**ZONING MAP CHANGE
STAFF REPORT**

Site Location: 1924 8th Avenue (1600 block Windsor Place) Mapsco: 76Q

Request: From: "I" Light Industrial
To: "PD/I" Planned Development for all uses in "I" Light Industrial plus mini-warehouse; site plan included.

SITE PLAN

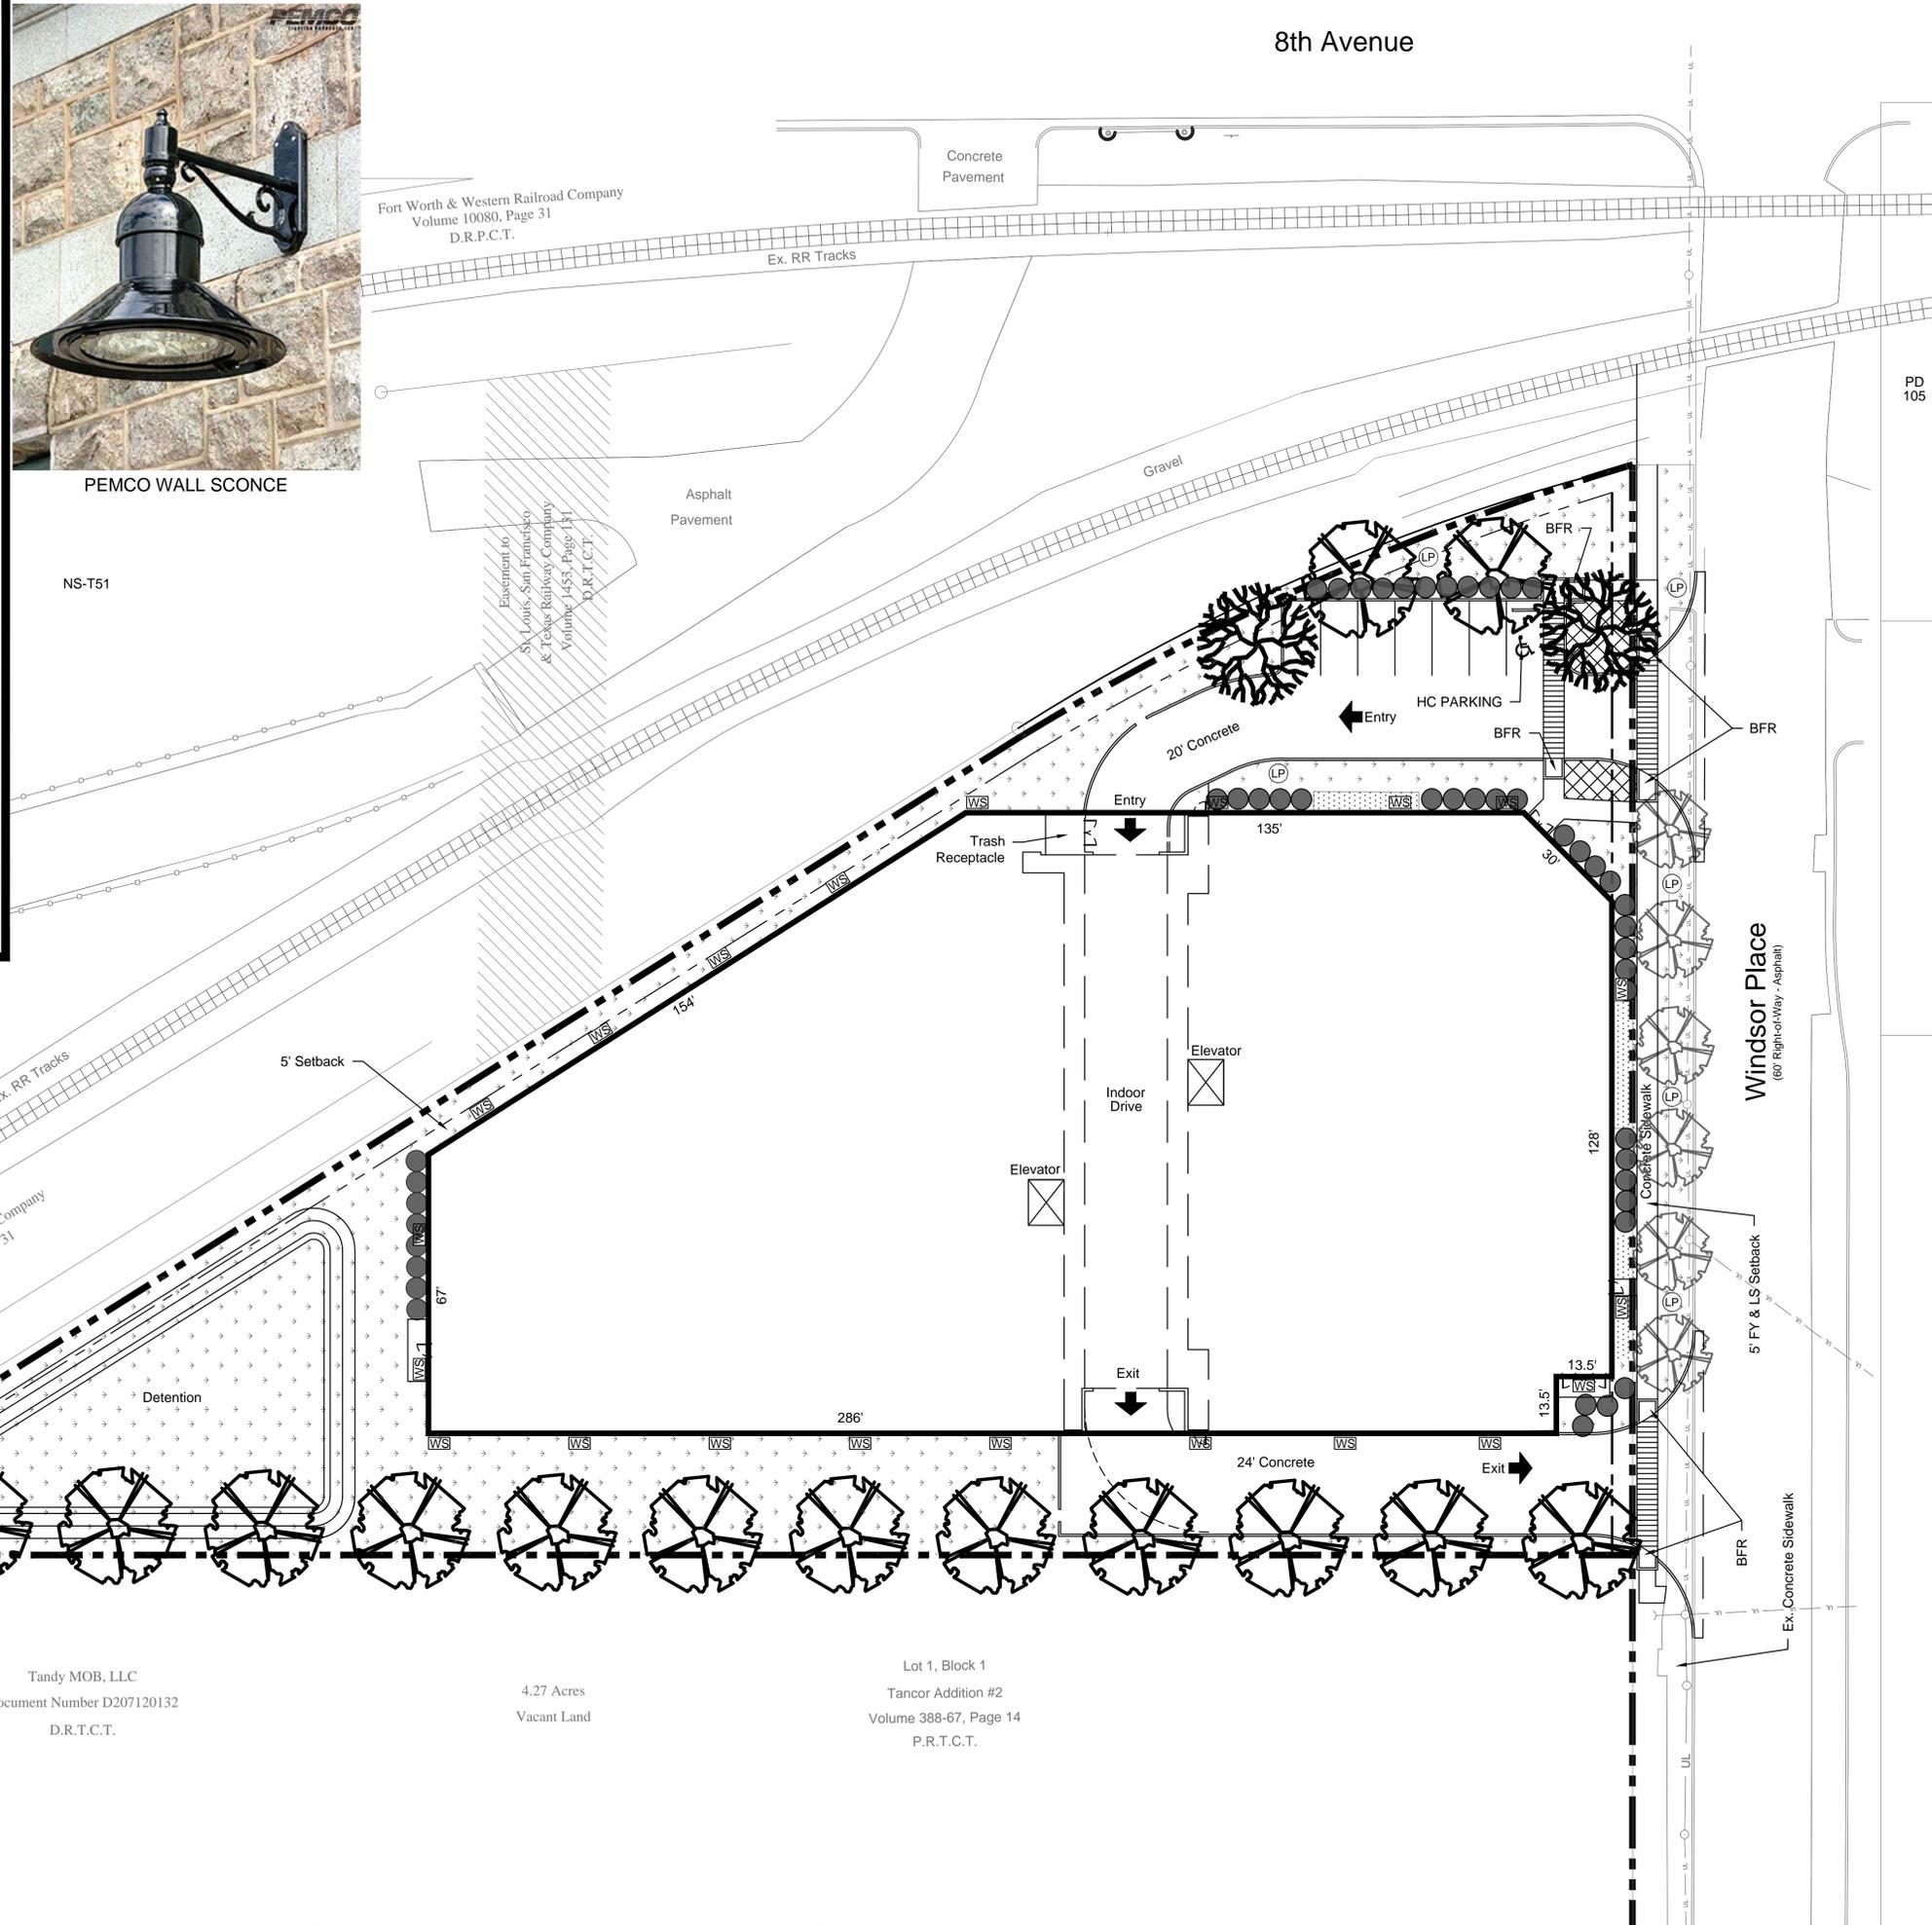
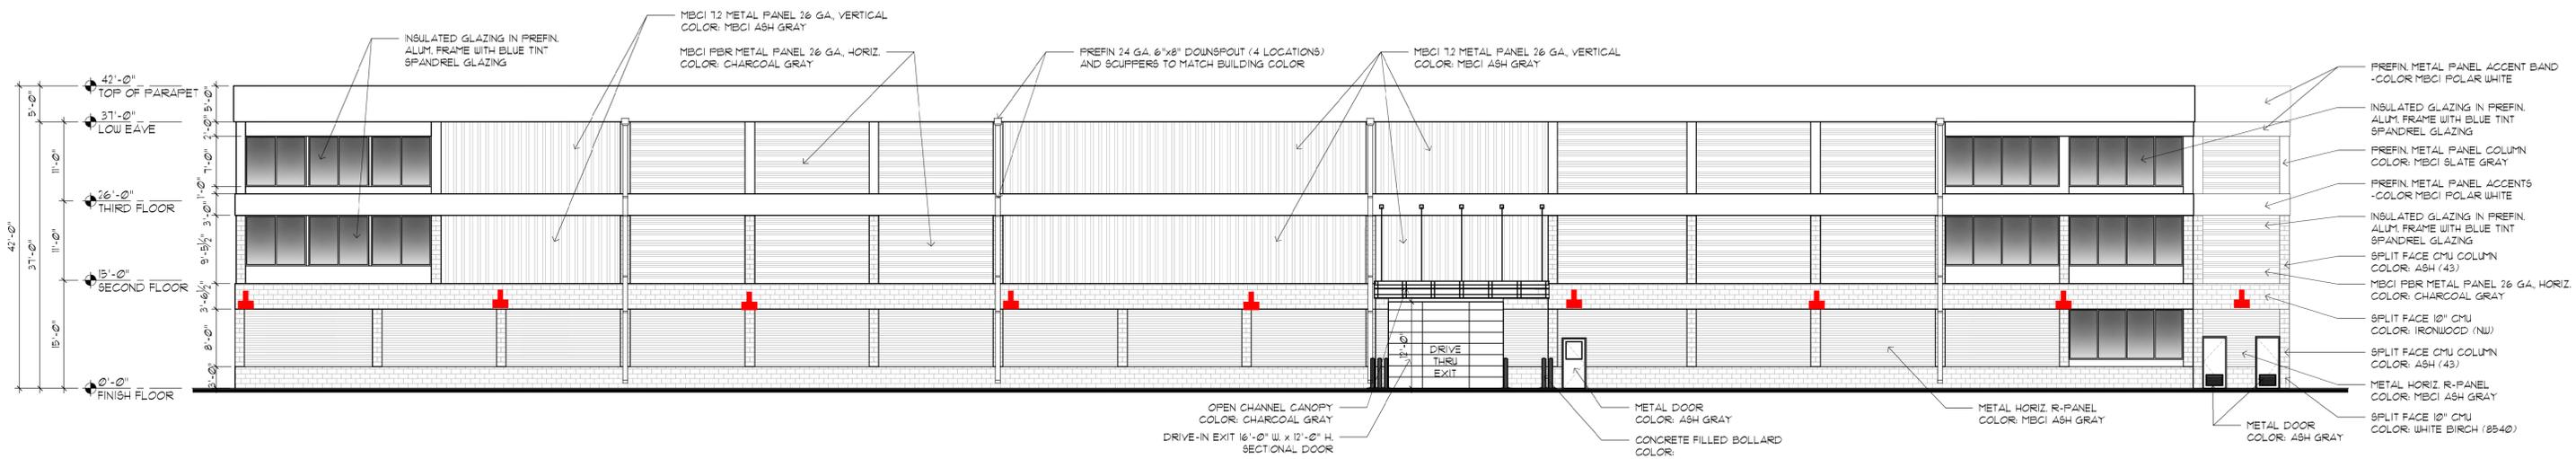
The site plan as submitted is in not general compliance with the zoning regulations. The key deficiency is:

1. 20 ft. projected setback along Windsor **(Waiver required)**

1. Gated entrances into secured areas must be designed in accordance with TPW's "Traffic Engineering Design Standards and Policy Guidelines".

1. PRV's required due to high water pressure
2. Pressure guaranteed at ground elevation
3. Sewer extension
4. Provide exclusive Sanitary Sewer easement to match construction plans

***No private plumbing crossing lot lines

***No permanent structures over lines and easements

Zoning Commission recommended a waiver to the item noted above.
